The Arcade, Dewsbury & 18-20 Corporation Street / 17 Foundry Street

Design and Heritage Statement Addendum

1705-BDP-AD-XX-RG-Z-00006

DRAWING TITLE: Ground Floor Removals Plan

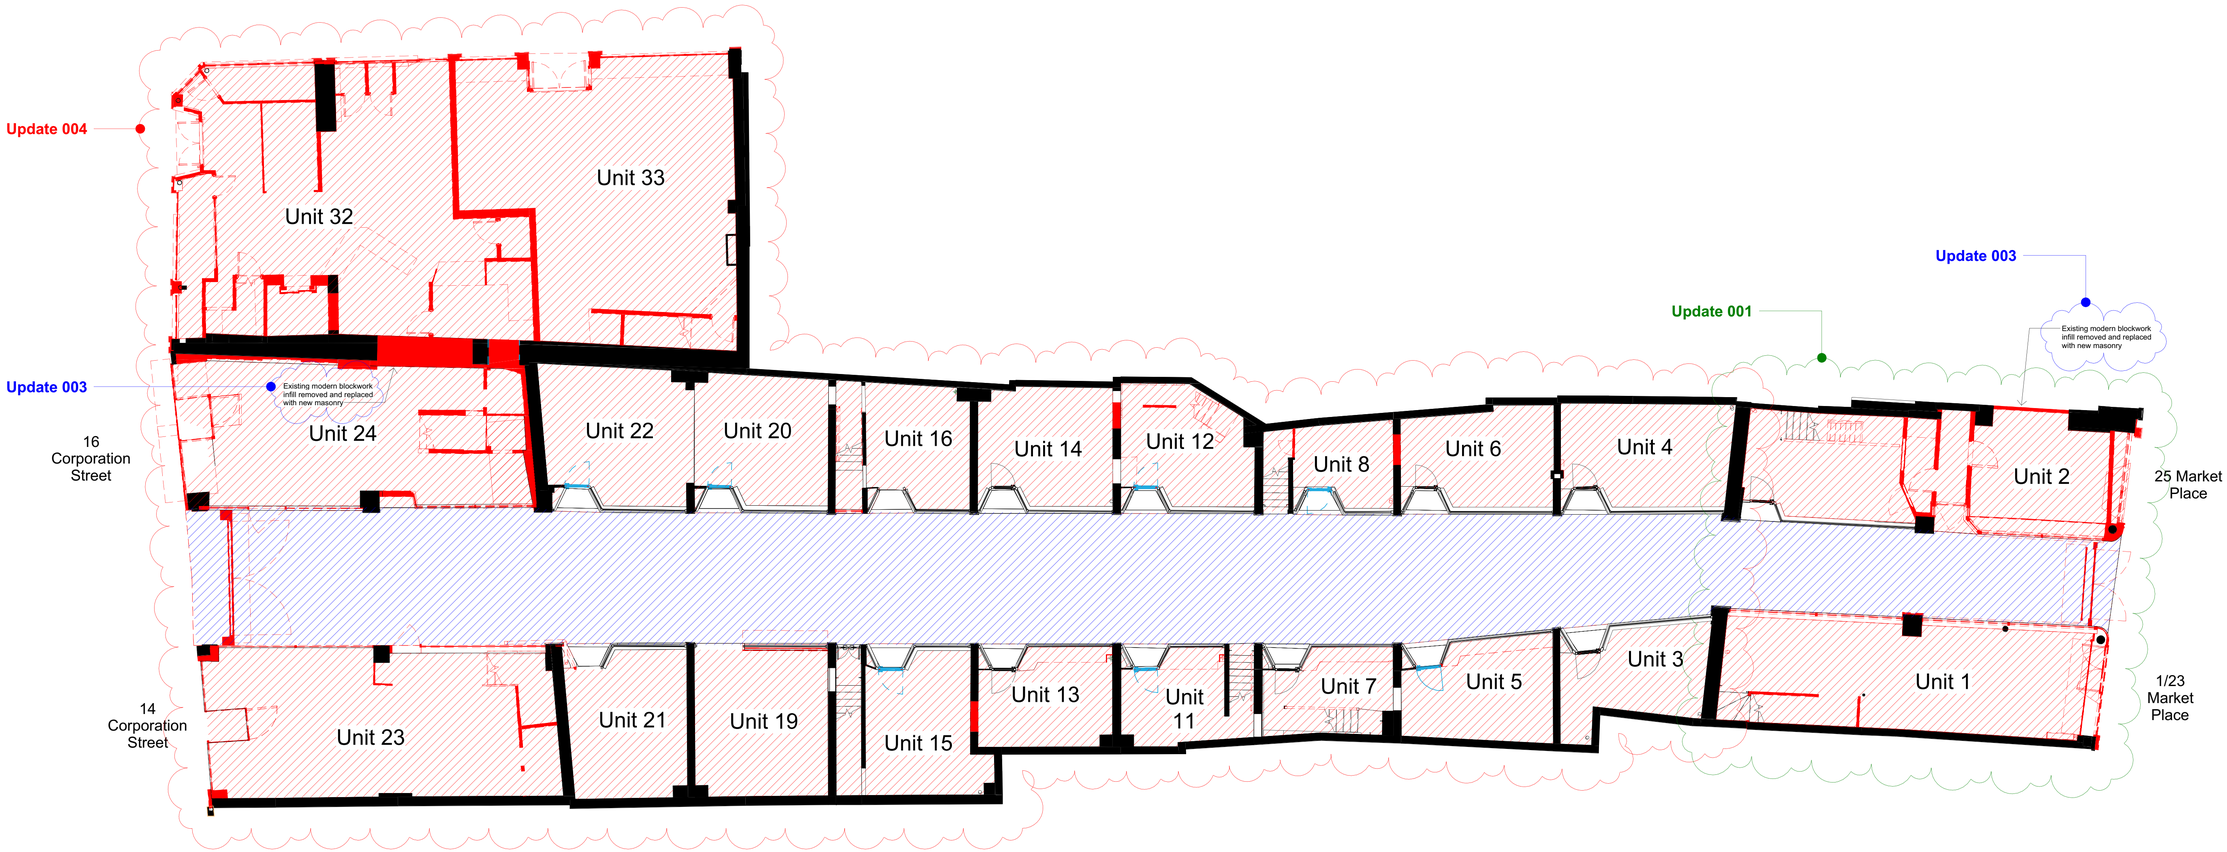
002	**25 Market Place** Unit 2	Internal partitions	At ground floor, the stair would exit into unit 2.	n/a	**LIFE SAFETY**: For safe fire evacuation, it is considered necessary for the stair exit to be separated from unit 2 to support continued viable and flexible uses.	Minor change to internal layout with new partition added to separate the stair exit from unit 2, partitions are reversible. This strategy has already had consent in unit 1.	**Negligible**	1705-BDP-AD-00-PL-A-20001_T01 1705-BDP-AD-SL-PL-Z-00003_T01	1705-BDP-AD-00-PL-A-20001_T02 1705-BDP-AD-SL-PL-A-00003_T02
003	**23-25 Market Place and 14-16 Corporation Street**	Masonry walls	Existing wall to be retained.	Following on-site opening up and the removal of modern finishes (e.g. plasterboard), several sections of wall have been found to be recent blockwork.	**LIFE SAFETY + PERFORMANCE**: These blockwork infills are mostly poorly built, not meeting the fire performance requirements or modern structural requirements to support continued viable and flexible uses.	Replace poor quality blockwork infills with new, to meet modern requirements.	**Negligible**	1705-BDP-AD-00-PL-A-20002_T01 1705-BDP-AD-02-PL-A-20002_T01	1705-BDP-AD-00-PL-A-20002_T02 1705-BDP-AD-02-PL-A-20002_T02

004	**Central Arcade, 14-16 Corporation Street, 18-20 Corporation Street and 17 Foundry Street** Units 3-8, 11-15, 19-24, 32 and 33	Floors	Existing floor slab to be locally removed for new building services and then reinstated.	The floor slabs in these units were found to be several thin layers of poor quality screed directly onto the soil, rather than actual slabs. The overall thickness of these layers was considerably thinner than expected for a proper slab.	**PERFORMANCE**: It would not be possible to dowel into the existing 'slabs' to reinstate areas of slab following the installation of new building services. It could lead to differential settlement between the existing areas of slab and the new infill areas preventing continued viable and flexible uses.	Remove more of the existing screed layers and install complete slabs to these units, to avoid future differential settlement. This strategy has already had consent in unit 16 and slabs are concealed under the consented floor finishes.	**Negligible**	1705-BDP-AD-00-PL-A-20002_T01	1705-BDP-AD-00-PL-A-20002_T02

DRAWING TITLE: First Floor GA Plan as Proposed

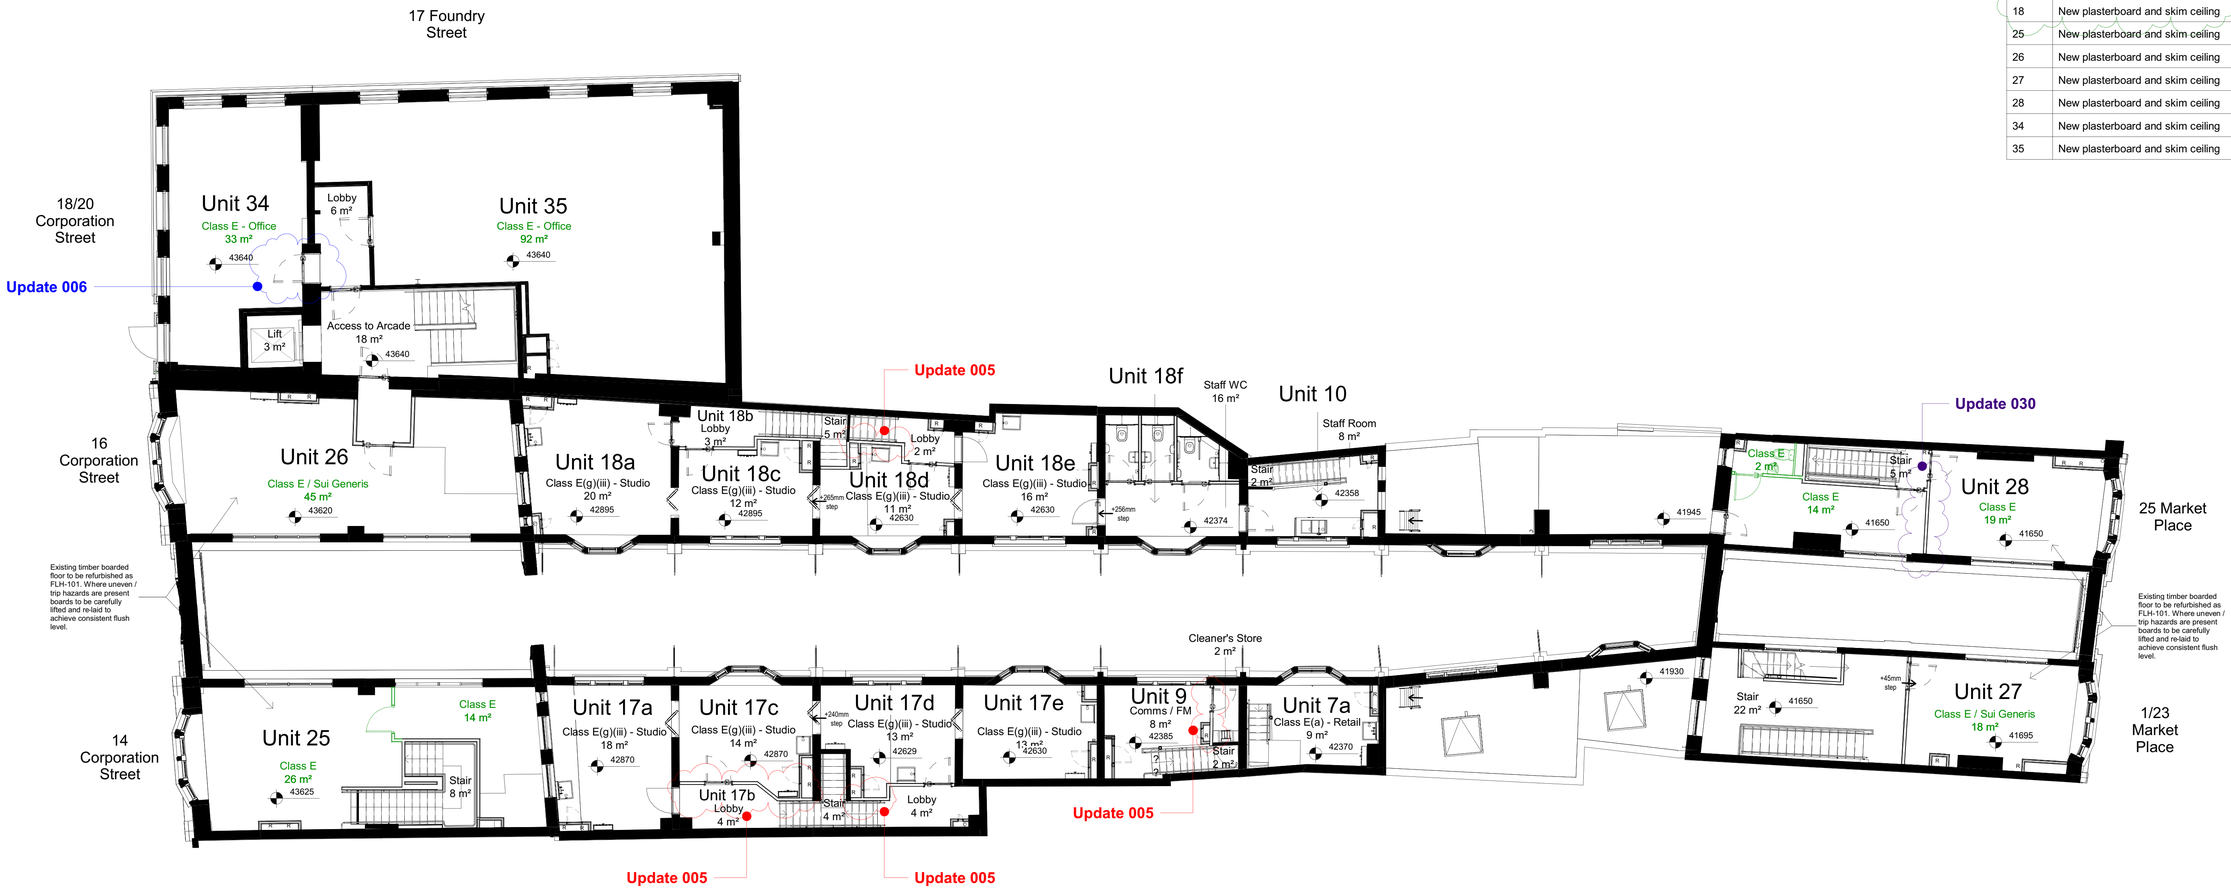
026	**Central Arcade**	Glazed roof structure	Cast iron trusses to be redecorated.	Following a fingertip survey of the existing trusses, cracking was noted to the top and bottom chords of several of the cast iron trusses.	**LIFE SAFETY + CONDITION**: The structural engineer confirmed the cast iron structure was unsafe in its existing poor condition resulting in future failure preventing continued viable and flexible uses Arcade-wide.	Install additional steel principal rafters to carry the roof load and relieve the existing cast iron trusses of their existing load. Cast iron trusses to remain in location and be resupported from the new steel rafters.	**Minor Adverse**	1705-BDP-AD-RF-PL-A-20005_P01	1705-BDP-AD-RF-PL-A-27001_P02
027	**Central Arcade** Units 7a, 9, 10, 17, 18	Ceilings	Repair damaged lath and plaster ceilings.	On close inspection, the ceilings were found to be in a poorer condition than expected.	**CONDITION**: The plaster had extensively debonded from the laths and therefore was not suitable for patch repair.	Remove damaged material and replace with plasterboard. This approach has already had consent for units 25, 26, 27, 28, 34 and 35.	**Minor Adverse**	1705-BDP-AD-01-PL-A-20001_T01	1705-BDP-AD-01-PL-A-20001_T02

Update 027

DRAWING TITLE: First Floor Removals Plan

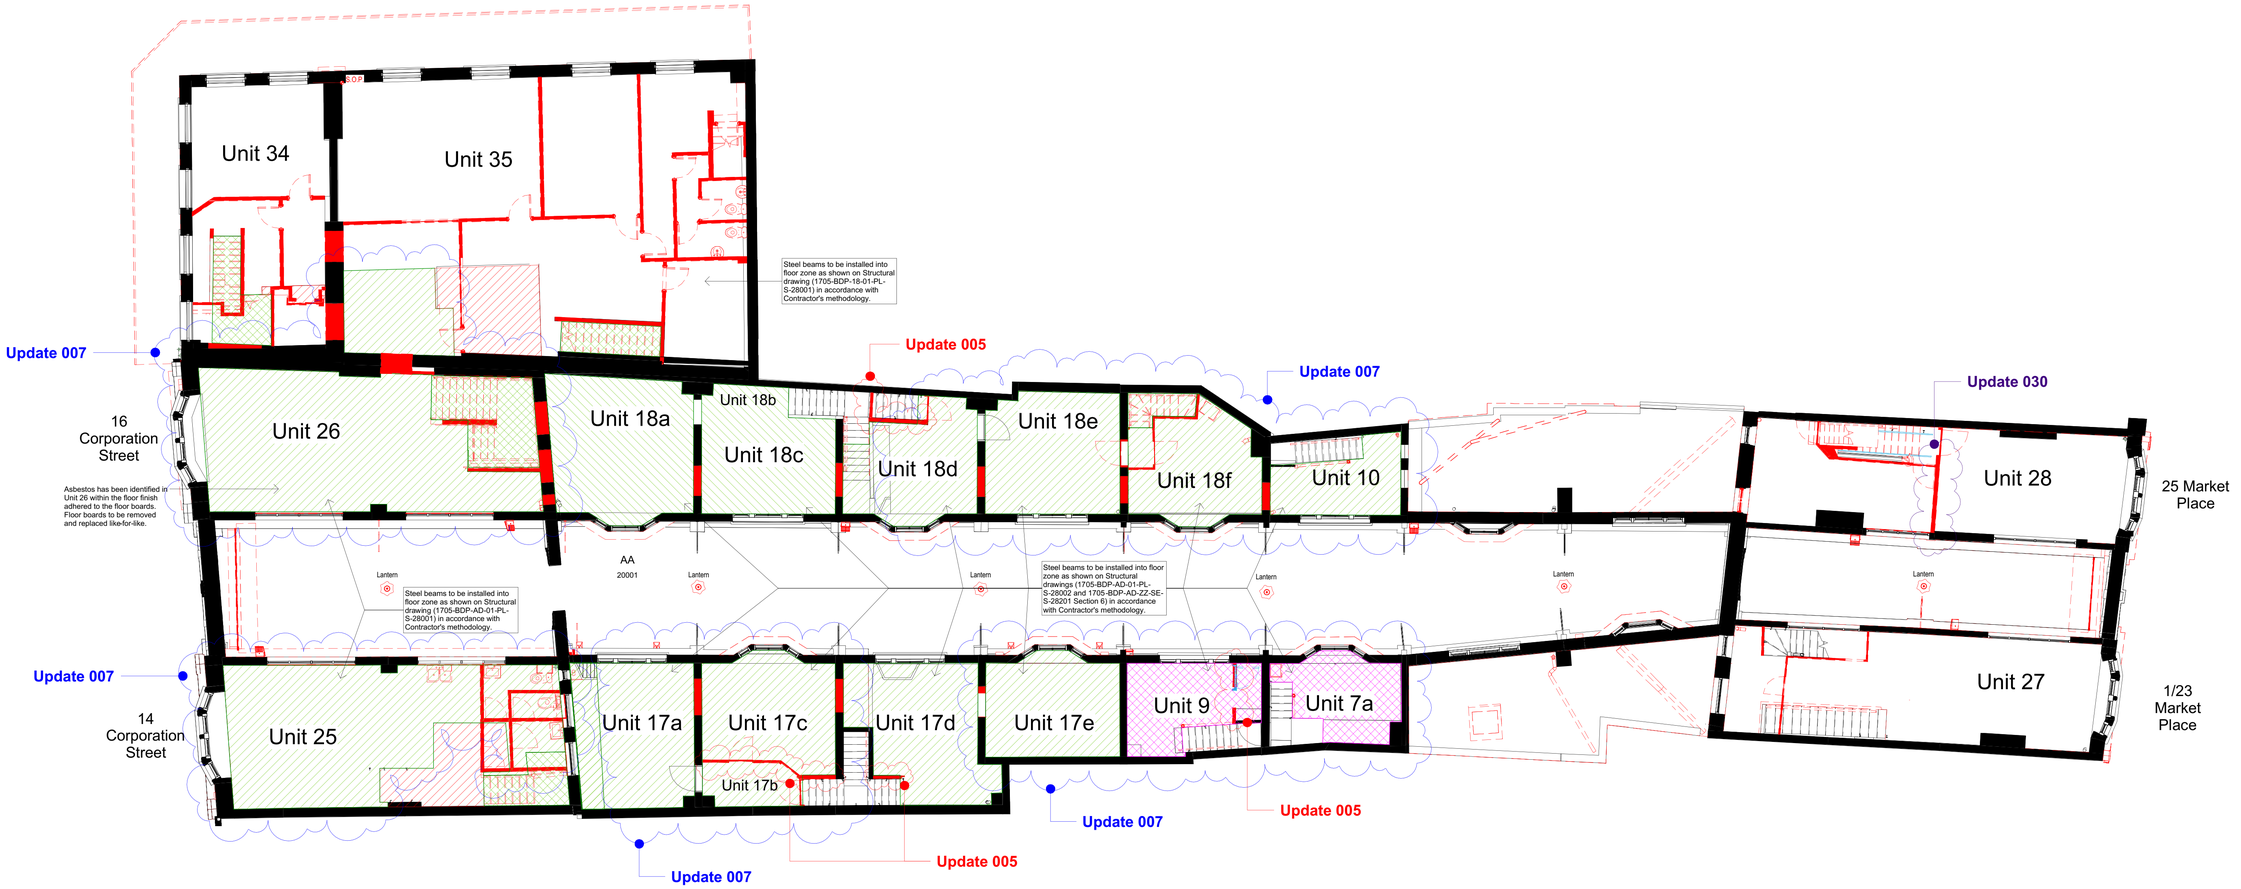
005	**Central Arcade** Units 9 and 17b	Internal partitions	Existing partitions were assumed to be historic lath and plaster partitions to be retained and upgraded to meet the new fire performance requirements for a 60-minute protected stairway where applicable.	Following on-site opening up, the partitions were found to be a mix of more modern construction and were generally poorly built incorporating hard board / MDF.	**LIFE SAFETY + PERFORMANCE**: These were not historic elements of the building with heritage value as evidenced by their absence on the historic plans in the West Yorkshire Archives, and it would not be practical to upgrade them to provide 60 minute fire resistance to support continued viable and flexible uses.	Replace these sections of partition with new plasterboard partitions to provide the required fire resistance. This is the same approach that had already had consent for the partitions forming the fire-protected stair in unit 18b on the opposite side of the arcade.	**Negligible**	1705-BDP-AD-01-PL-A-20001_T01 1705-BDP-AD-01-PL-A-20002_T01	1705-BDP-AD-01-PL-A-20001_T02 1705-BDP-AD-01-PL-A-20002_T02

006	**18-20 Corporation Street and 17 Foundry Street** Unit 34 / 35	Stairwell and door	No lobby to top of stair. New door to swing outwards.	n/a	**LIFE SAFETY**: For safe fire evacuation, it has been proposed that these units should be lobbied from the protected stair, and the door to unit 34 should swing into unit 34, to avoid impacting the escape route from unit 35 and support continued viable and flexible uses.	Minor change to internal layout with new lobby added. Door to swing inwards (into unit 34)	**Negligible**	1705-BDP-AD-01-PL-A-20001_T01 1705-BDP-18-ZZ-PL-A-00002_P06	1705-BDP-AD-01-PL-A-20001_T02 1705-BDP-18-ZZ-PL-A-00002_P07
007	**Central Arcade** First floor units	Floors	Units 17d, 18a, 18b, 18c and 18d: replace the floors due to wet and dry rot. Units 7a, 9, 10, 17a-c, 17e, 18d-f, 25, 26 and 35: Refurbish the floors: lift boards, strengthen and repair existing joist structure. Reinstate existing boards wherever practical and supplement with new.	Additional timber surveys have revealed extensive wet and dry rot had already been identified in units 17d, 18a, 18b, 18c and 18d, 25, 26 and 35. Further wet and dry rot was found in the remaining units affecting the joists and floorboards.	**LIFE SAFETY + CONDITION**: The existing joists were damaged by wet and dry rot to the extent that their condition was very bad and strengthening them was not practicable to support continued use. The floorboards were similarly damaged and in poor condition so that only short lengths could be recovered for reuse.	Replace the timber joist floor structure to the remaining units in the areas that have been affected by wet and dry rot (as had already been had consent for units 17d, 18a, 18b, 18c and 18d). Recover all lengths of floorboard which are suitable for reuse and install them in units 7a and 9, with new floorboards to matching profiles used elsewhere. This will allow two units to retain and evidence the appearance of their original floor.	**Minor Adverse**	1705-BDP-AD-01-PL-A-20002_T01	1705-BDP-AD-01-PL-A-20002_T02

Update 007

PROJECT TITLE: Dewsbury Arcade
BDP JOB NUMBER: P3001705
DRAWING TITLE: Plans as Proposed
SCALE: As indicated @ A1
DATE FIRST ISSUED: 15/11/21
DRAWING NO: 1705-BDP-18-ZZ-PL-A-00002-
REVISION: P07

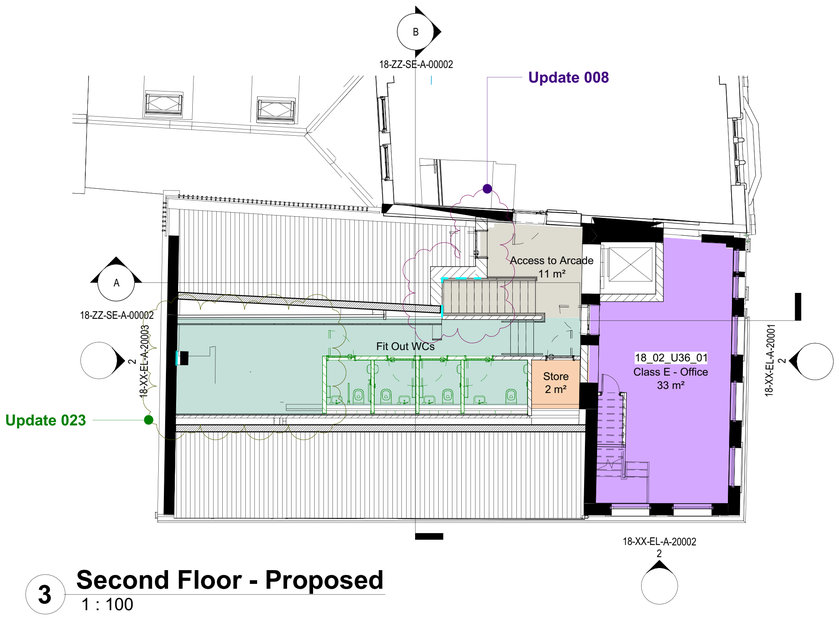
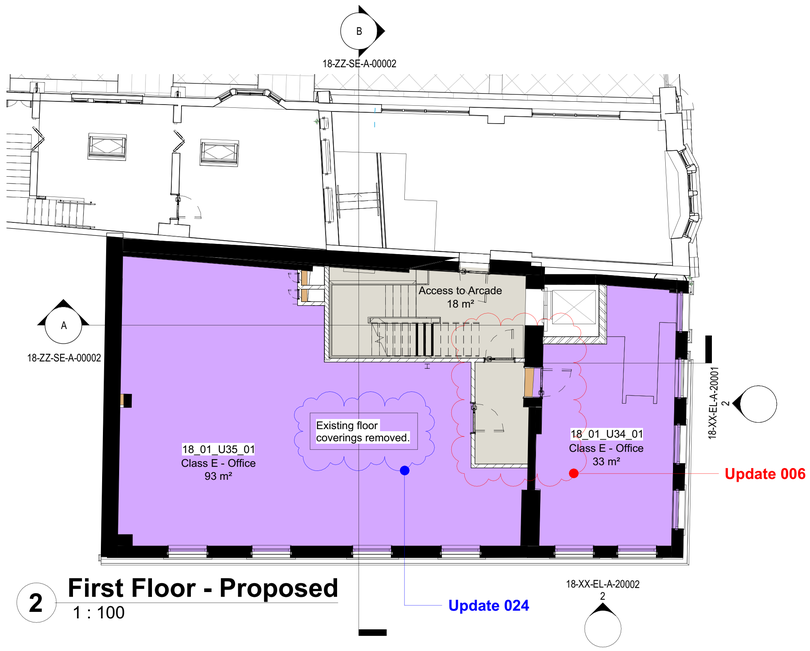
028	**18-20 Corporation Street and 17 Foundry Street** Units 32-36	Ceilings and walls	Repair damaged ceilings and walls.	On close inspection, the ceilings and wall finishes were found to be in a poorer condition than expected, incorporating modern materials and with extensive damp.	**CONDITION**: Where present, plaster had debonded from the laths and masonry and therefore was not suitable for patch repair. There is also a need to treat dry rot in the masonry, requiring plaster to be removed.	Remove damaged ceiling finishes and replace with plasterboard finishes. Remove damaged wall finishes and replace with lime plaster. This approach has already had consent elsewhere in the arcade buildings.	**Minor Adverse**	1705-BDP-18-ZZ-PL-A-00002_P06	1705-BDP-18-ZZ-PL-A-00002_P07

Finishes to ceilings to be removed and replaced with plasterboard. Finishes to walls to be removed and replaced with lime plaster.

Update 028
